SI-240510

Service-Information Turbocharger

Turbochargers with different compressor housings

Vehicle Manufacturer: FORD Transit V363

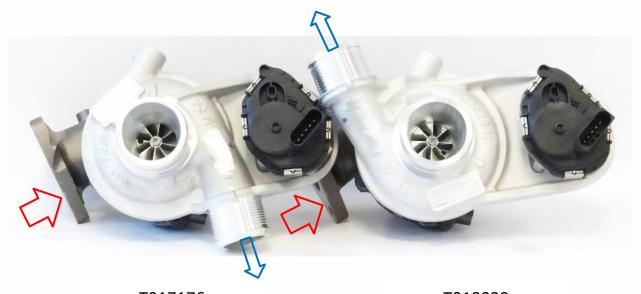
The vehicle manufacturer has introduced a modified turbocharger for vehicles with all-wheel drive. However, it should be mentioned that this modification is not obligatory for all vehicles delivered. Mixed installation of the two variants is possible.

The turbochargers differ in the design of the compressor housing. The compressor outlet is oriented 180° in the opposite direction. These turbochargers are not interchangeable.

The external distinguishing feature is the placement of the compressor outlet.

Before starting the assembly work, the turbocharger supplied has to be compared with the old part. The check has to be carried out before filling the turbocharger with the initial filling additive.

T917176
Garrett design-nb.
(838417-xxxxx)

without all-wheel drive

T918039
Garrett design-nb.
(838452-xxxxx)
with all-wheel drive
